CITY OF DOVER

PLANNING TECHNICAL REVIEW COMMITTEE –AGENDA

1. 10:30 AM – 11:15 AM: Site Review for Our Place, Inc., Assessor's Map H, Lot 6-4, zoned R-20, located at 105 Durham Road. (Proposal is to provide a 9-unit group housing facility for adults with Intellectual Developmental Disabilities (IDD) with associated parking, drainage and landscaping.) (SITE-2024-0004) *This item was previously heard on Thursday, May 30, 2024.*

**Re: Application for Site Plan Review – Technical Review
Our Place – Adult Supportive Living Facility
105 Durham Road, Dover
Tax Map H, Lot 6-4
P5496**

SHEET NUMBER:
6 / C-2

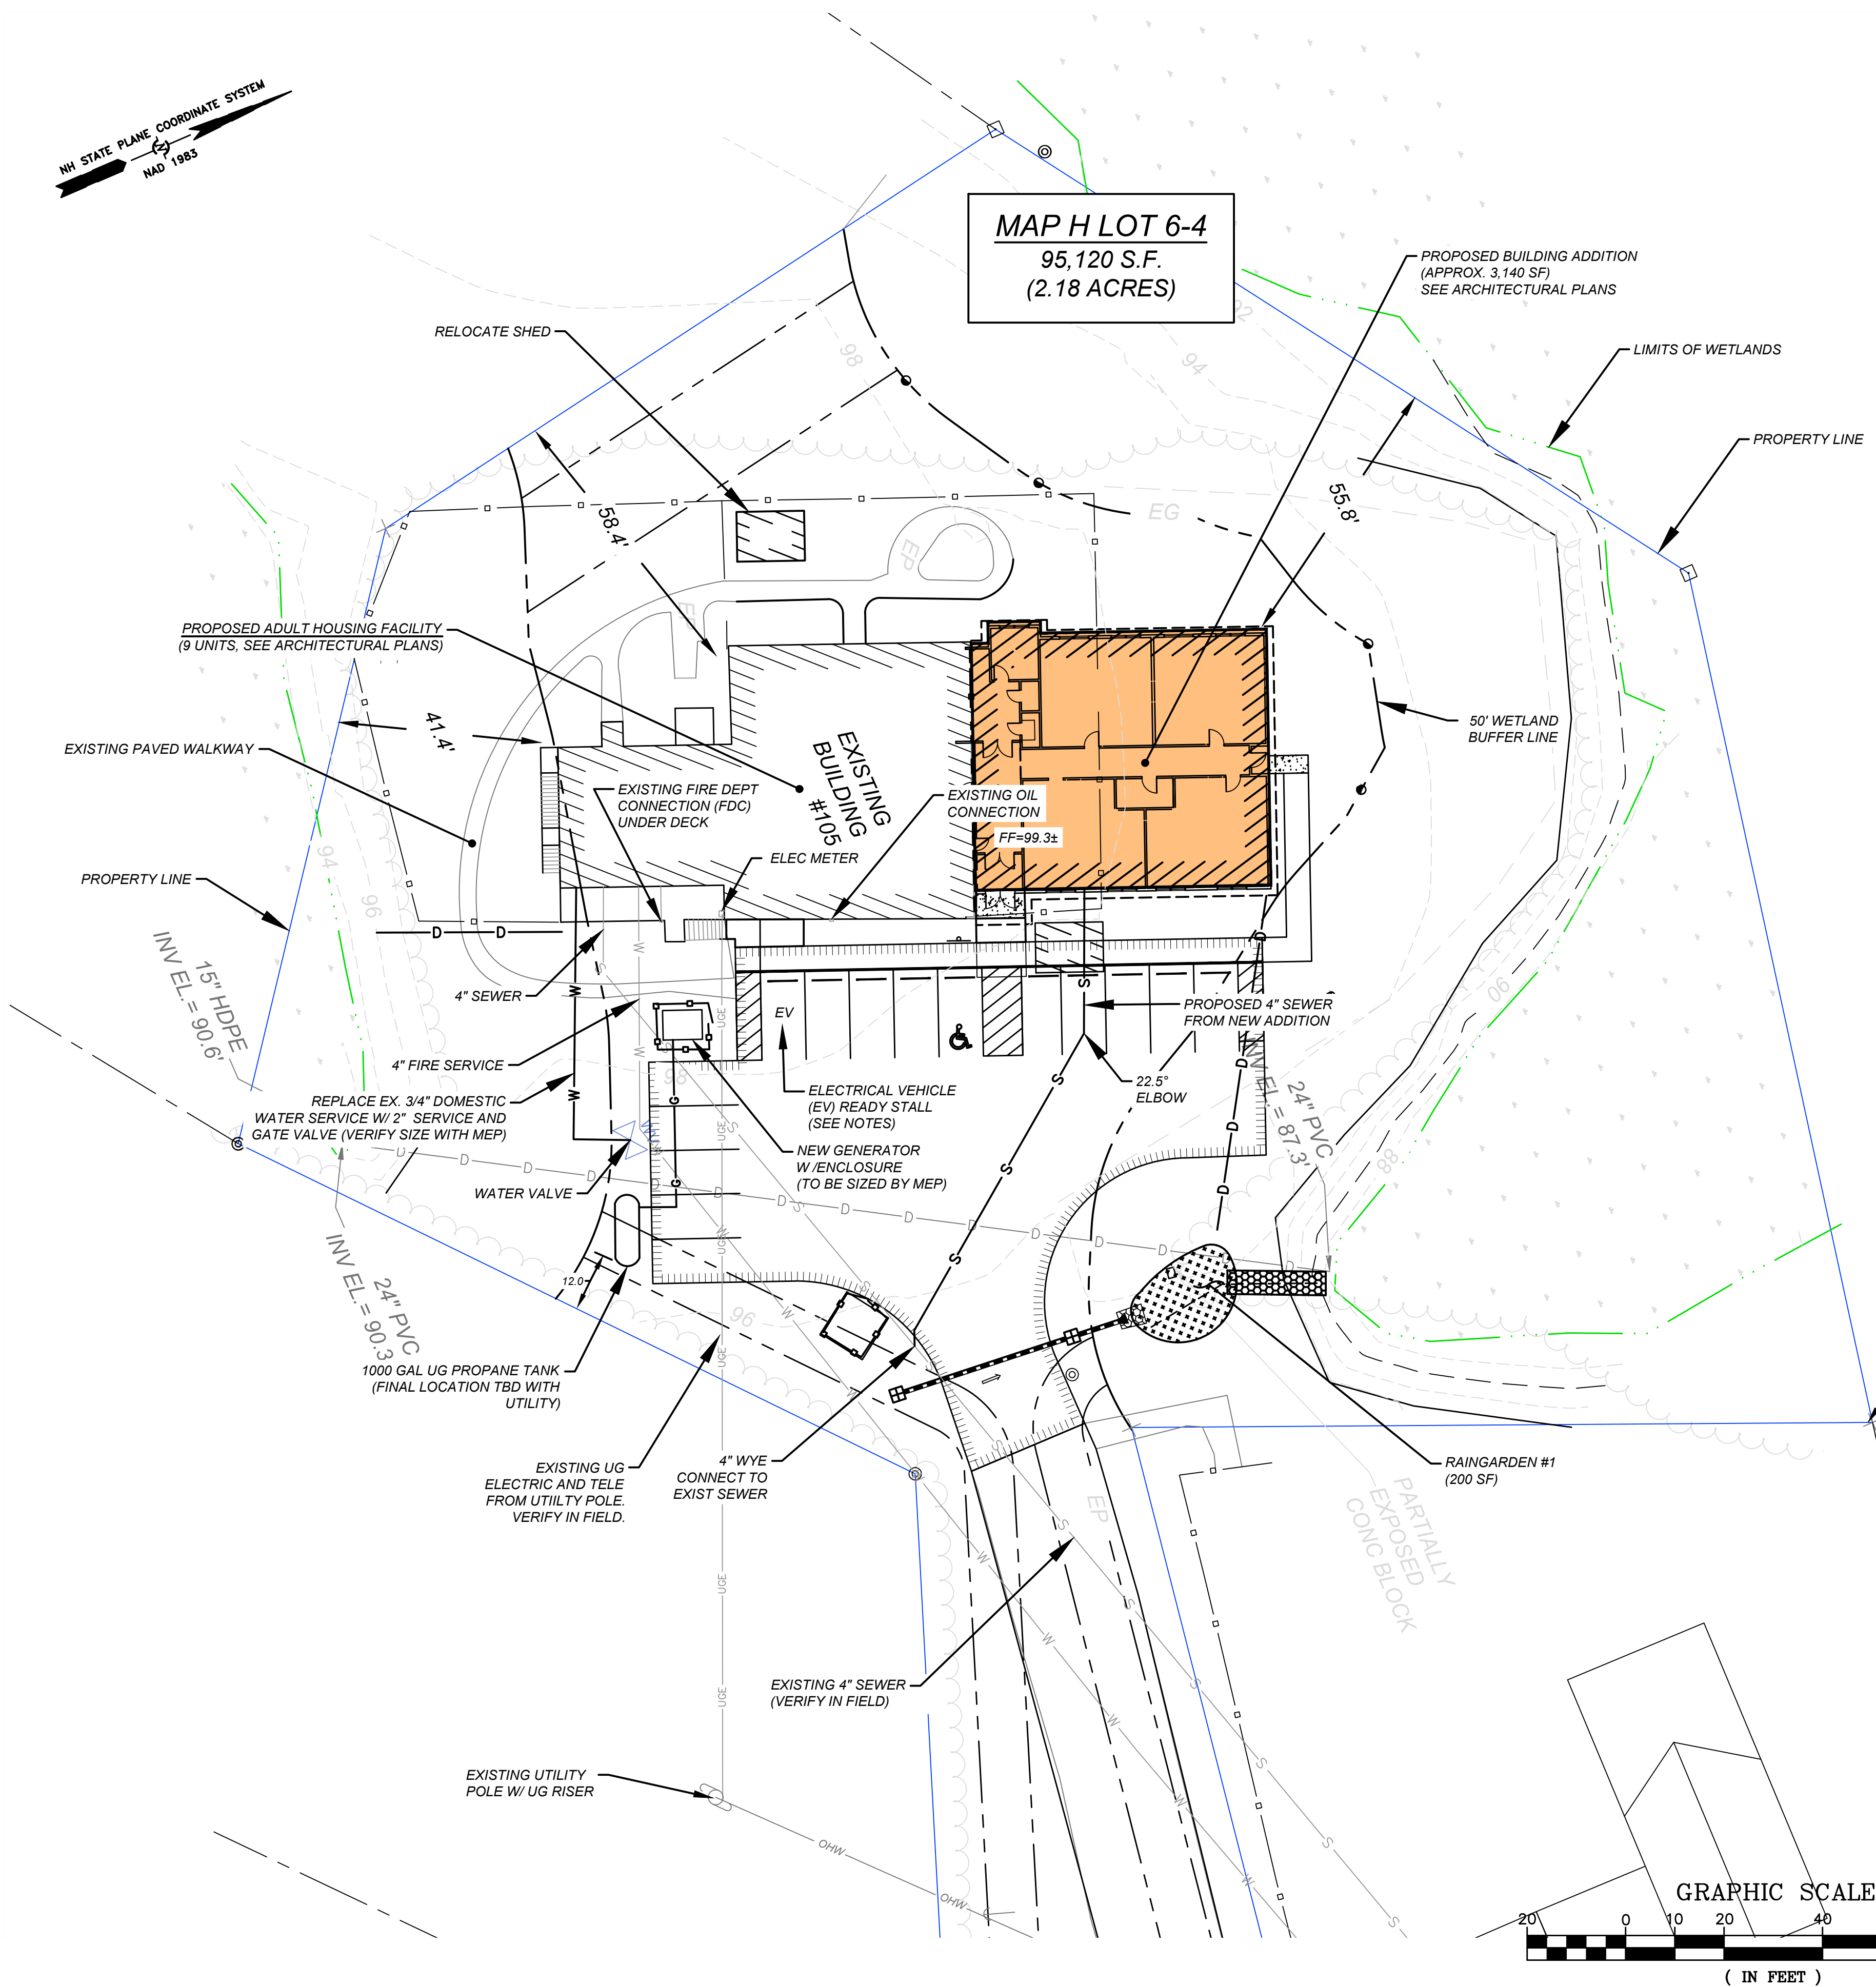
- Sheet GN-1
 - Sewer manhole not shown on the legend. Are there any on the property?
- Sheet C-2:
 - What is the condition of the 24-inch culvert running below the new paved parking lot? Recommend videoing the line to determine if it needs to be replaced or repaired.

- Sheet C-2:

Response: The line is plastic and appears in good condition.

DOVER T-1 FIRE TRUCK
(TURNAROUND)

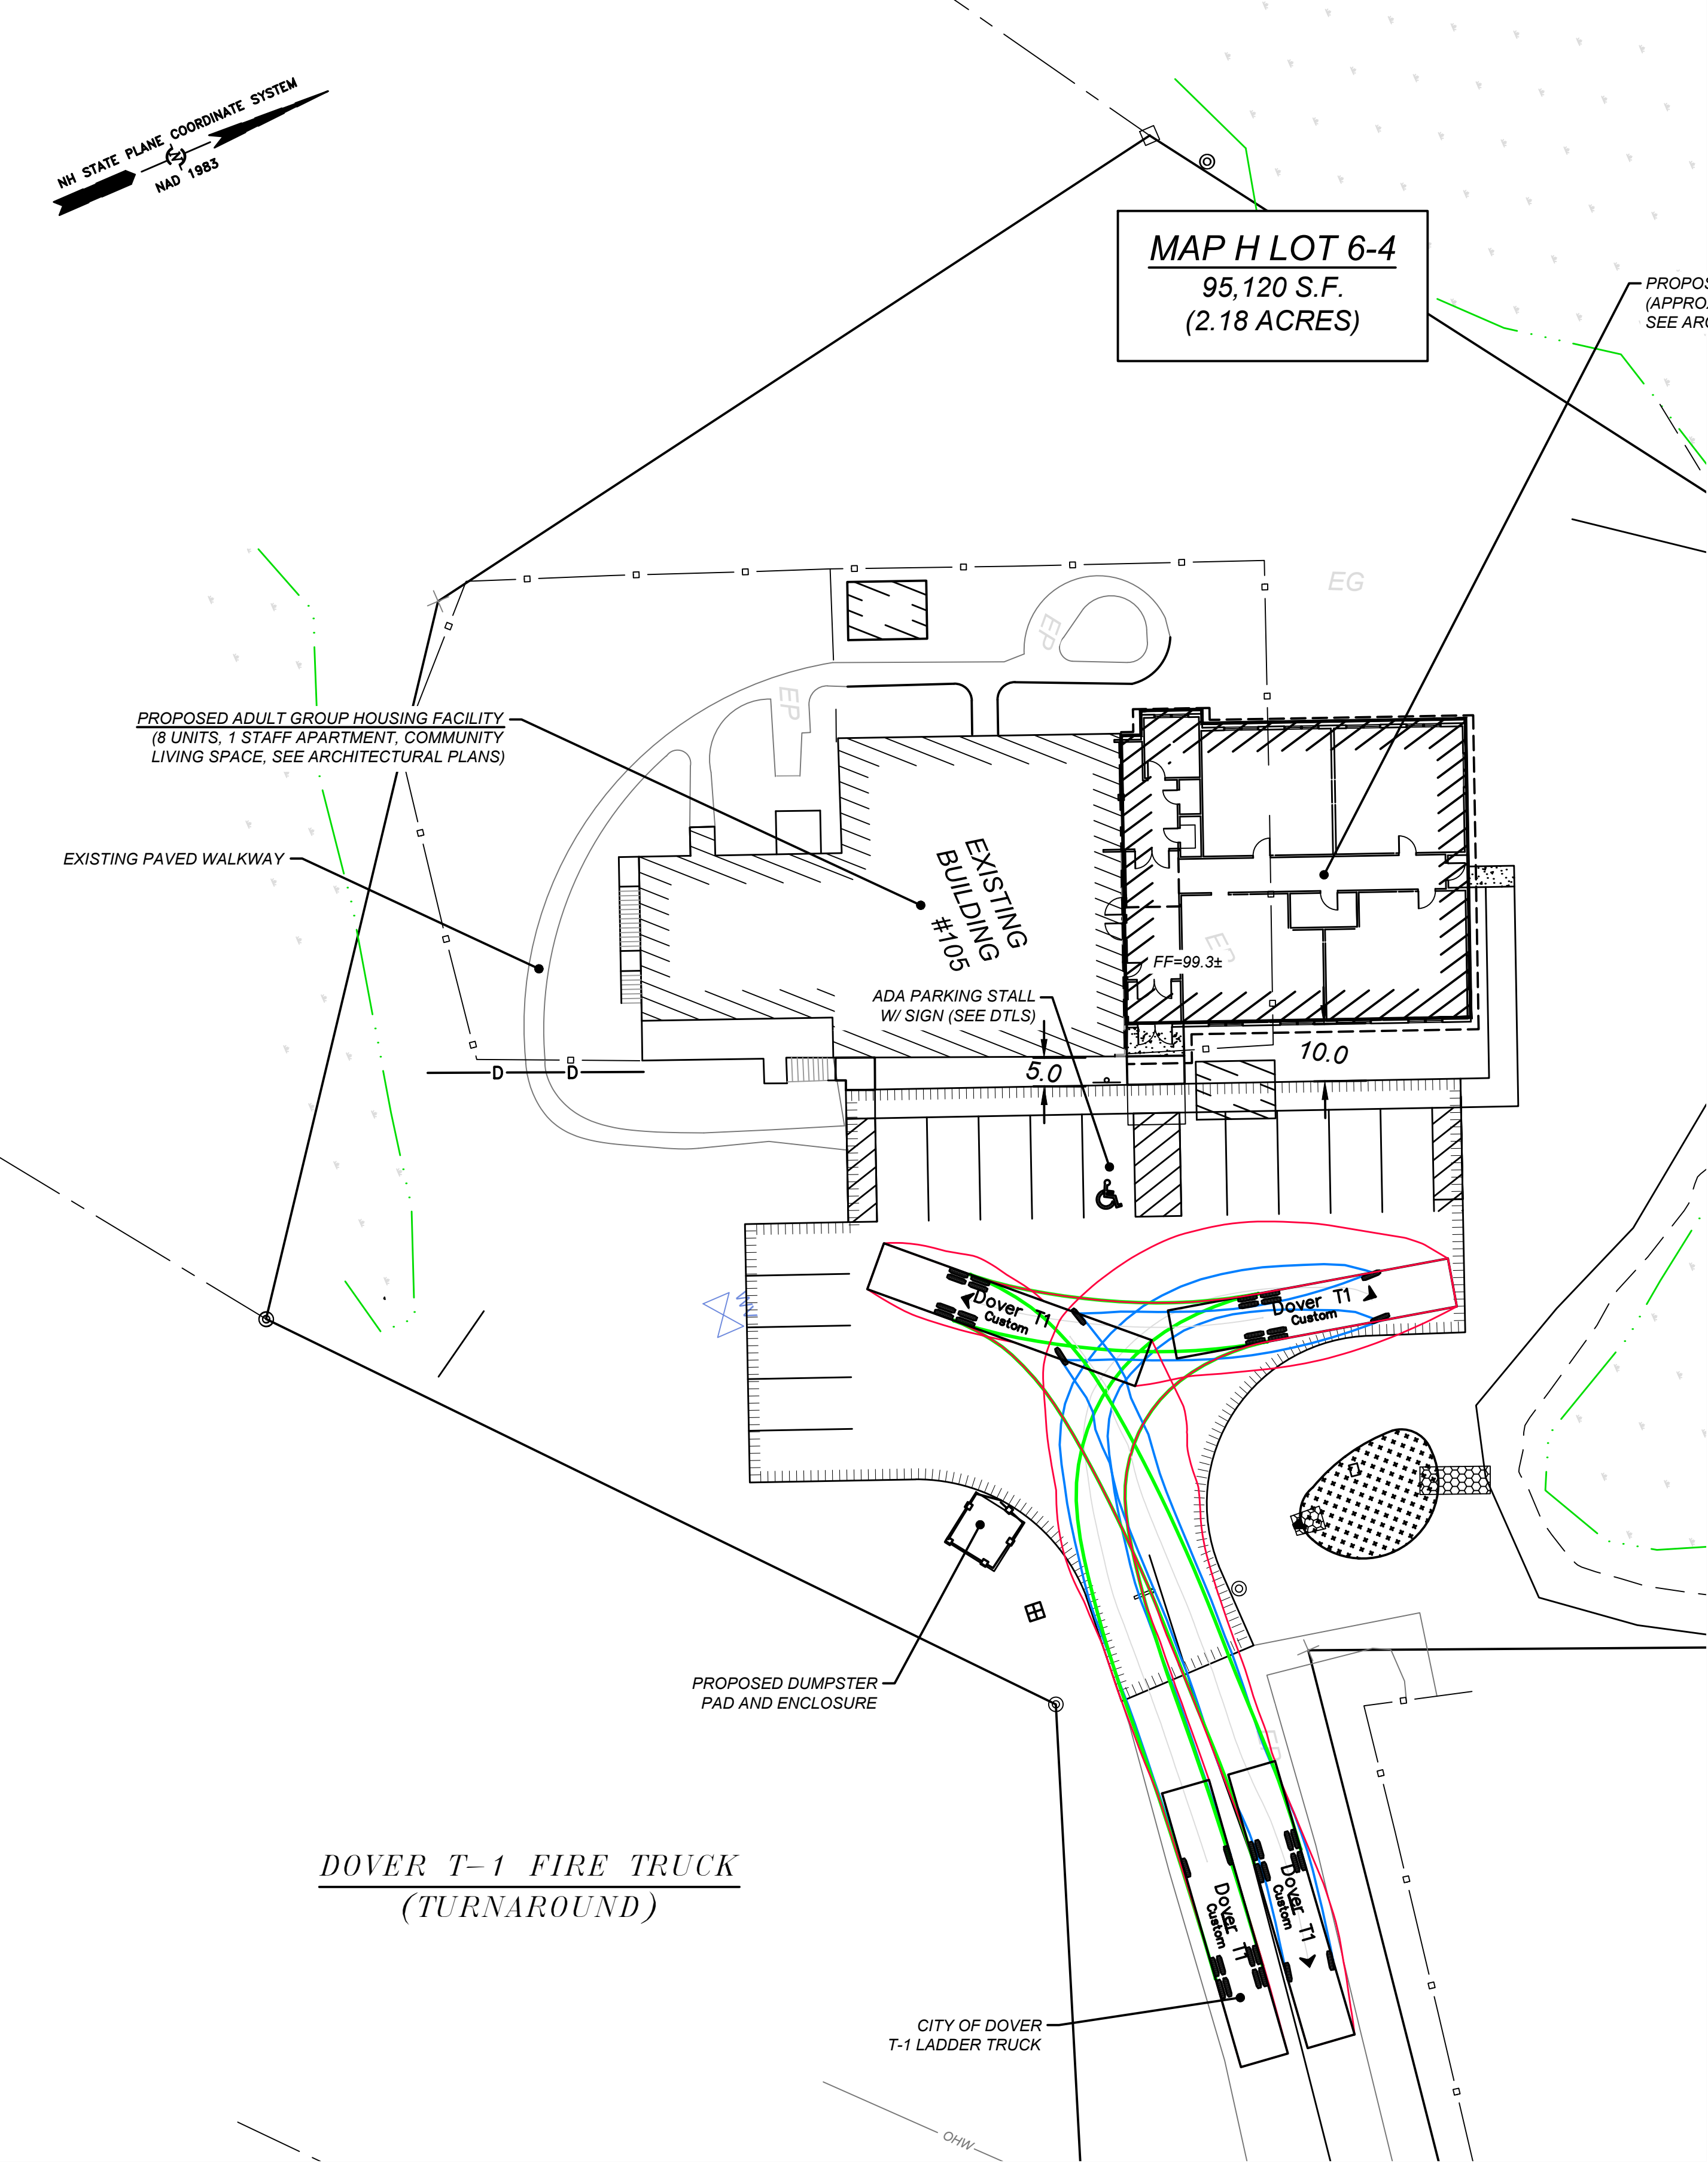
Item Review Name	Department	Assigned User	Status	Assigned Date	Due Date	Completed Date
IS Building Official	Fire / Inspection Services	Maxfield, Jim	Requires Re-submit	05/07/2024	06/04/2024	05/17/2024
Comments: 1) Provide site plan in compliance with chapter 18 of NFPA 1 for site access. 2) Provide a turning template for fire dept. apparatus

4 BITUMINOUS SIDEWALK NOT TO SCALE
D-2

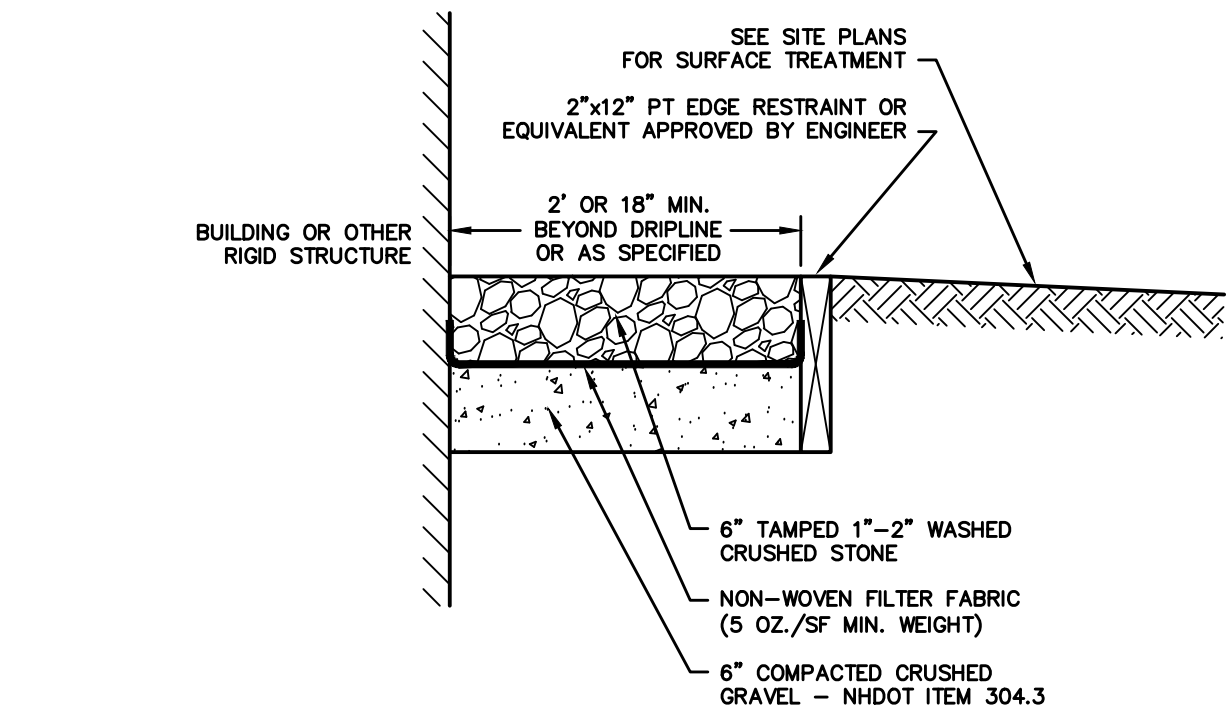
- D-1:
 - This sheet states that a NPDES GP is not required then states that an NOT is required from the EPA. Please clarify which is correct.
- D-2:
 - Where is the bituminous sidewalk proposed?

Response: Note 14 for sequence of events (filing NOT) is removed.
- D-2:
 - Where is the bituminous sidewalk proposed?
Response: The walkway to the north door is bituminous.
